CONNECTION ASSESSMENT & APPROVAL PROCESS ASSESSMENT SUMMARY - ADDENDUM

**Project: Merivale TS
Replace 115kV Oil Breakers L1L5, L1LT22,
and L3L12, and Associated Breaker
Disconnect Switches**

CAA ID: 2002 – EX109

Date: April 7, 2003

Figure 1 - Merivale TS 115kV Switchyard

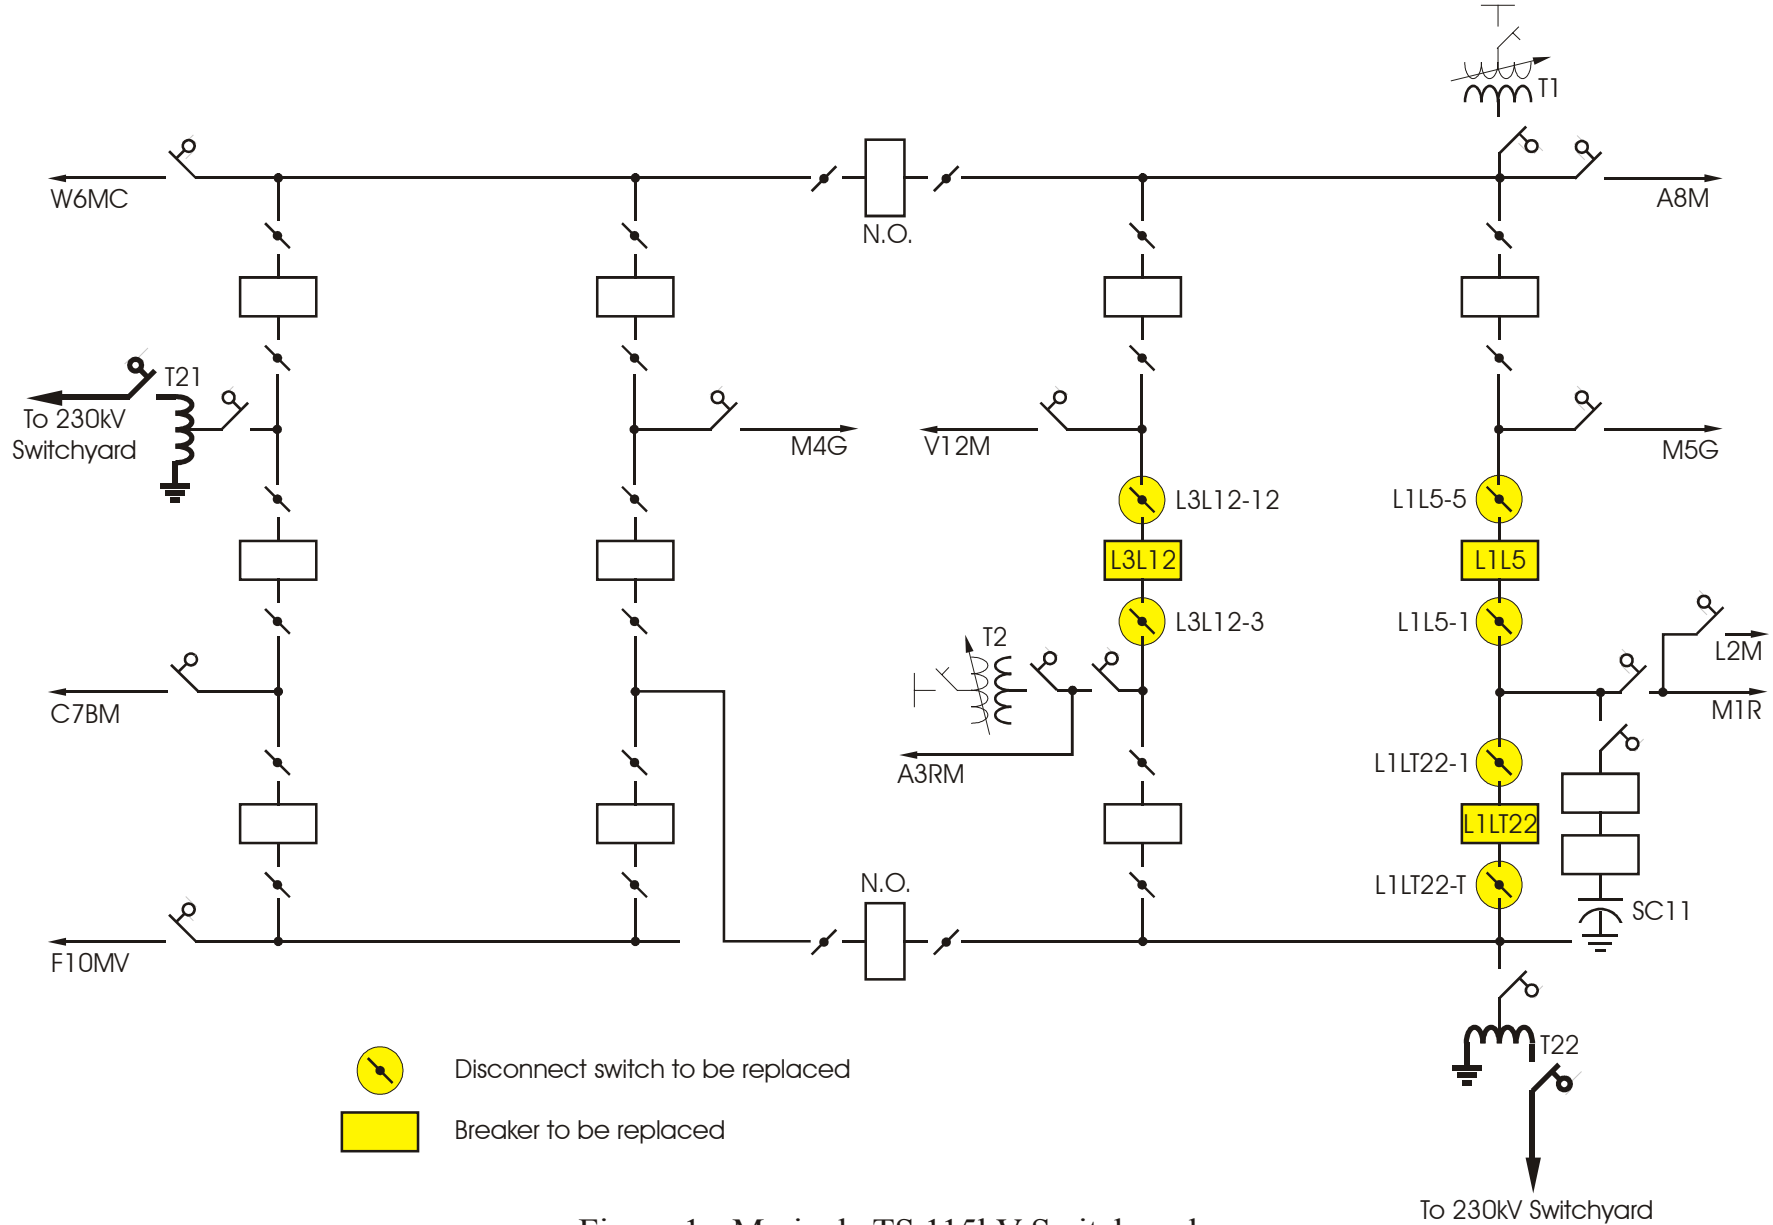
Hydro One Network Inc. has advised the IMO that instead of breakers with 50kA interrupting capability as originally proposed, the new SF₆ breakers will have an interrupting capability of 40kA. The applicant is therefore requesting approval for the revision to the project.

Hydro One Networks Inc. is proposing to replace three existing 115kV 1,200A bulk oil circuit breaker with 20.2kA symmetrical fault current interrupting capability and their associated 1,200A disconnect switches with new 145kV SF₆ circuit breakers and new 138kV disconnect switches. The breakers and disconnect switches that are to be replaced are identified in Figure 1.

The proposed 40kA SF₆ breakers would be adequate and would not adversely affect the reliability of the IMO-controlled grid.

However, it should be noted that even though the replacement breakers would be adequate, they do not comply with the Transmission System Code requirement of having maximum fault interrupting capability of 50kA for 115kV breakers. Should a third party initiate a development that increases the fault level at Merivale TS 115kV bus beyond the capability of the replacement breakers, then Hydro One Networks Inc. would be expected to bear the cost of having to replace these breakers again.

Based on the above assessment, it is recommended that approval for the revision be granted to the applicant.
